Re: Resubmission - Special Land Use Approval for 47500 Six Mile Road

Proposed Use: Private Childcare

PROJECT 47500 6 Mile Road 6 Mile Rd. and Beck Rd. Nothville Township

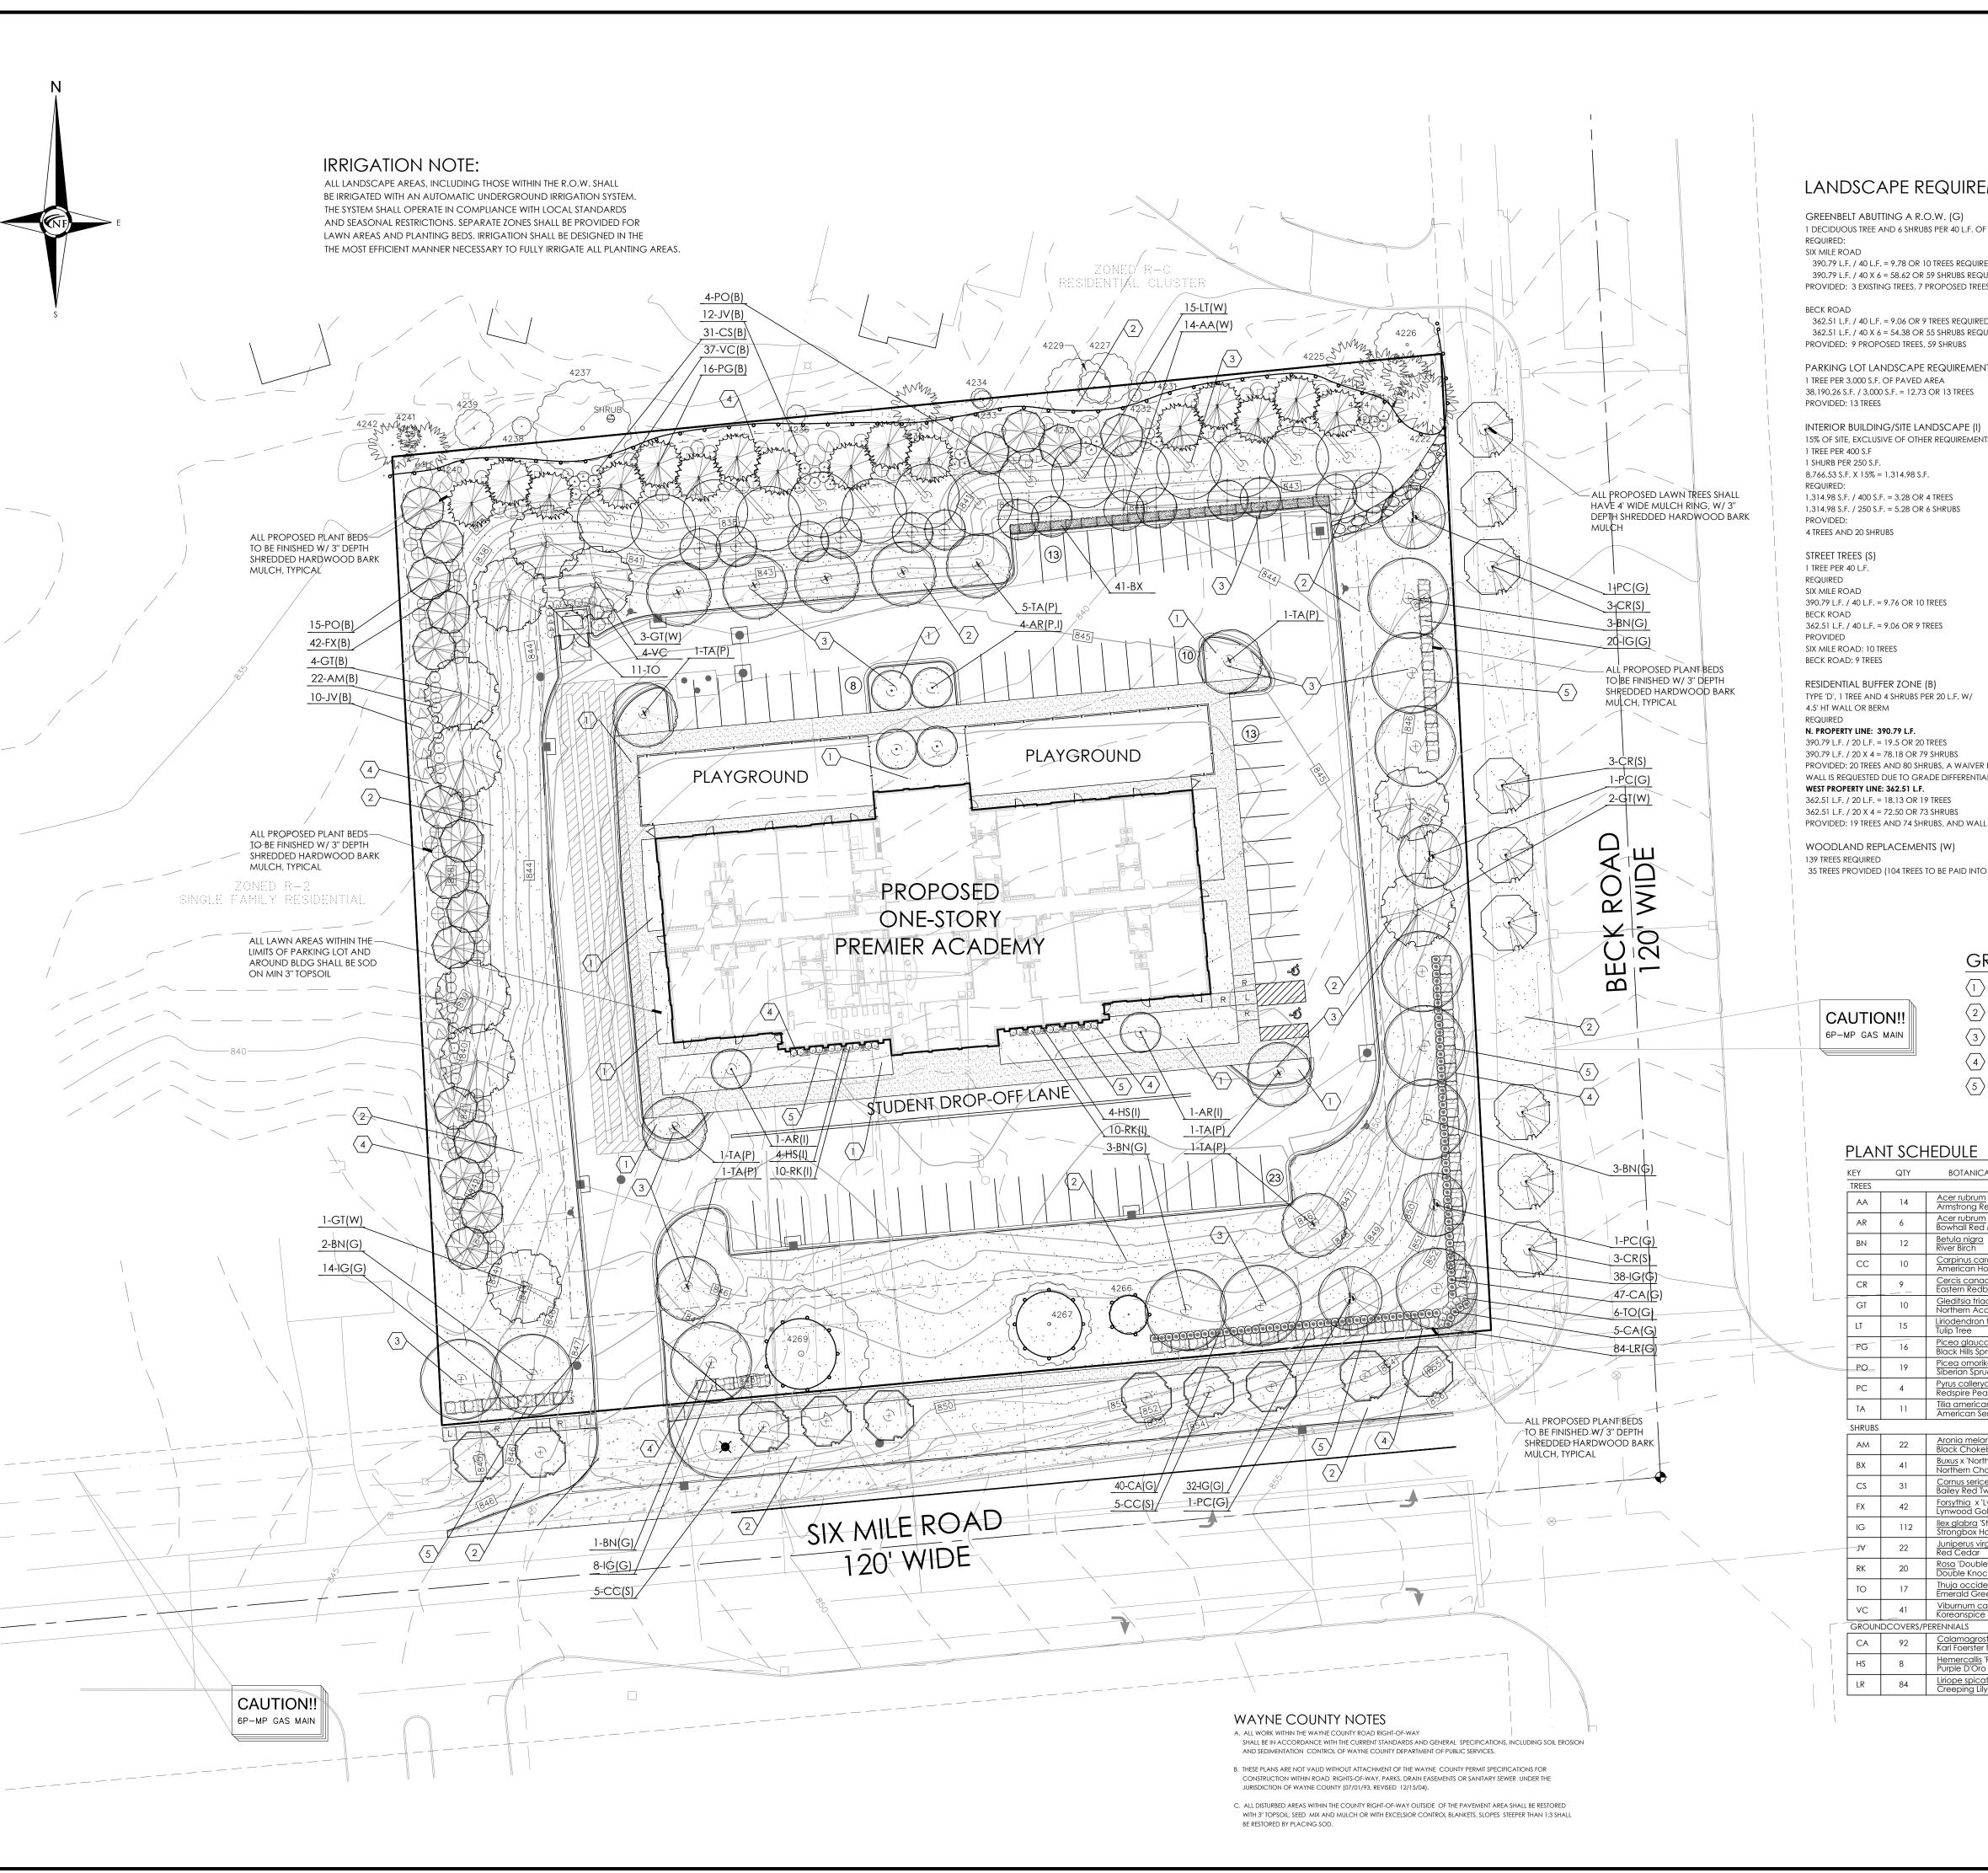
During the Planning Commission meeting held on March 22, 2022, comments were made about the proposed site that could be changed to better compliment the surrounding residential community. It was noted in disfavor that elevation was significantly higher than that of the surrounding properties. Specifically, the residential area to the north of the site.

Although the elevation difference between the two properties is an existing topographical feature, a revision has been made to the civil site plan to reduce this elevation difference so the facility can blend in more seamlessly.

The site has been lowered by approximately 1.50 feet. To accomplish the lowering of the site and still maintain reasonable slopes on the drive access to Six Mile Road, the improvements on the site were shifted approximately 18 feet. 1.50 feet is the maximum that we could lower the site without significantly revising the layout or exceeding recommended pavement slopes and ADA requirements. The shift of the site elements has additionally created a more visually dense landscape screen which will help create a more opaque barrier between Premier Academy and the subdivision.
